Subject: Village Lighting

From: William Thiess
Sent: Tuesday, June 9, 2020 5:25 PM
To: Michael Chidgey <mchidgey@fpua.com>
Cc: Larry Lammers <lammers@fpua.com>; Donna Dennis <donna.dennis@stlucievillagefl.gov>; Scott Dennis <scott.dennis@stlucievillagefl.gov>; Richard Neill <richard.neill@stlucievillagefl.gov>
Subject: Lighting for North Indian River Drive

SLV Lighting		Colonial Fixtures		JOB #	
	DATE	DESCRIPTION	BY: AP	SCALE	DESIGNED	SHEET
	ELECTRIC & GAS ENGINEERING		VERIFY SCALE BAR IS EQUAL TO	1" =		
	1701 SOUTH 27TH STREET		ONE INCH ON ORIGINAL DRAWING	14'		
	P.O. BOX 1178 (24000)		ADJUST ALL SCALED DIMENSIONS			
	FT. PIERCE, FLORIDA 34947		ACCORDINGLY			
	(772) 486-1600 / FAX (772) 461-1908

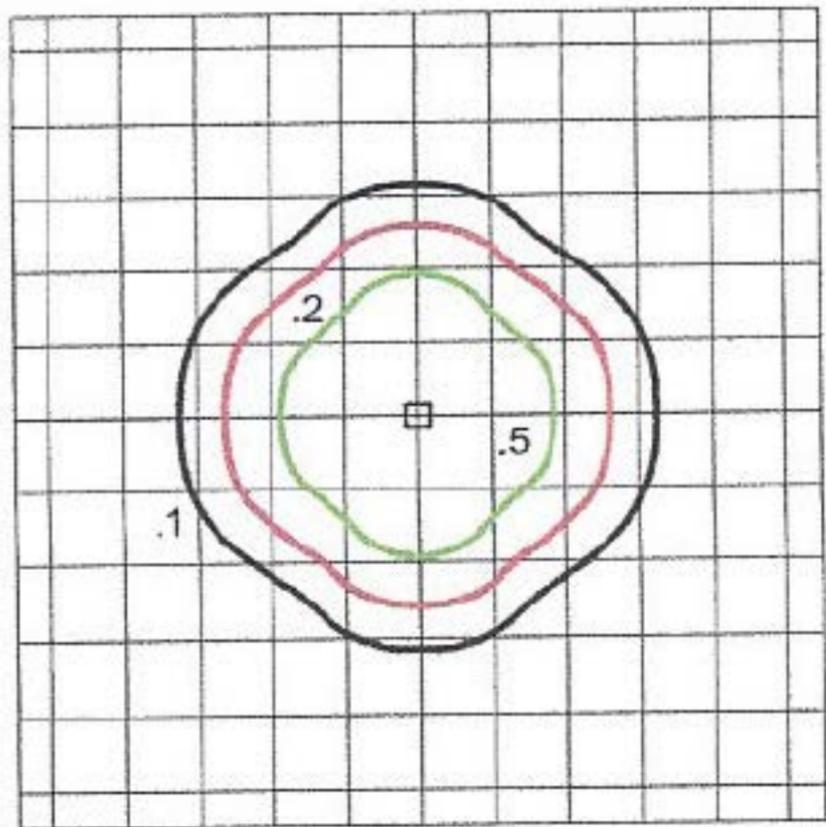
1. Can the elongated light pattern shown on the bottom left of page 4 be achieved?
2. On that figure, it looks like the fixture puts 10% illumination (573 lumens) on the ground at about 4.5 x 16', or 72' from the base. Is that correct?
3. Can a blackout panel be installed on the west panel of the fixture if requested by residents?
4. The figure you sent to me a while back showed 14 of these fixtures on the west side of the road with an average spacing of about 220 feet. With 10% illumination at 72 feet from the base of the pole, 220' spacing would minimize dark areas between most of the fixtures, correct? Also, wouldn't doubling the spacing to 440' result in a lot of dark road?

1. No, unfortunately ours looks like this (the top one):
2. I believe those numbers indicate footcandles. To put the numbers in perspective, a parking garage like the one at city hall should be around 5fc and a typical gas station runs around 12.5fc at the pumps.
3. We did not purchase the blackout panels with these fixtures. In the past maintenance of accessories has been troublesome, so we decided to remove them from our latest light selections.
4. These fixtures provide limited light output. The value these provide is that areas looking to achieve low, but uniform, light levels can do so easily. Due to the even spread of light projected by these fixtures, we can achieve good light uniformity numbers meaning very few hotspots – this makes it a lot easier on the eye.

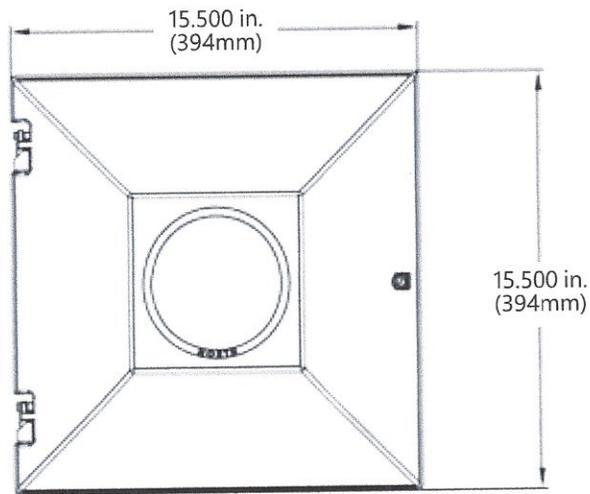
I received the attached layout from Michael Chidgey for installing Colonial Decorative lights on the east side or the west side of North Indian River Drive. The yellow circles and lines in that attachment are for placing lights on the east side of the road. The dollar figures represent the cost to put lights at those locations. These decorative lights are typically installed at no cost to the customer if power is readily available at the desired location. The installation cost in those cases is recovered through the monthly rental fee of \$12.26 per light. To provide coverage on the south end of the drive for this nine-light configuration, two lights would need to be added where power is not readily available. Adding those two lights would cost \$8,700 and that would be the total cost for this option. We can discuss the pros and cons of the “east side” option at Tuesday’s meeting.

The green circles and lines show locations on the west side of the road that are feasible for locating these decorative lights. FPUA used a spacing that ranges from 121 feet to 339 feet but is consistently closer to the 220-foot average spacing (see my notes on spacing, attached). That is a reasonable spacing for this type of light if the objective is to put some light on most of the road. Eight of these lights can be installed at zero cost, but the other six would involve significant cost (\$17,100 total). The monthly rate for each of these decorative lights is \$12.26, so the 14 lights would cost \$171.64 per month (plus taxes or power cost adjustments, if applicable) versus \$163.28 for the 8 taller LED lights we discussed at the last meeting.

If we opted to only install the eight Colonial Decorative lights that cost \$0 on the west side of the road, the spacing would be very irregular, ranging from 121 feet to 956 feet. This arrangement would provide accent lighting at the \$0 locations but would result in much of the road being dark.

EPTT
120-277V
(05AA50)

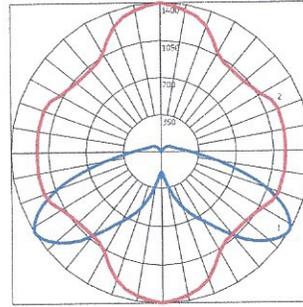
1. Can the elongated light pattern shown on the bottom left of page 4 be achieved?
2. On that figure, it looks like the fixture puts 10% illumination (573 lumens) on the ground at about 4.5 x 16', or 72' from the base. Is that correct?
3. Can a blackout panel be installed on the west panel of the fixture if requested by residents?
4. The figure you sent to me a while back showed 14 of these fixtures on the west side of the road with an average spacing of about 220 feet. With 10% illumination at 72 feet from the base of the pole, 220' spacing would minimize dark areas between most of the fixtures, correct? Also, wouldn't doubling the spacing to 440' result in a lot of dark road?
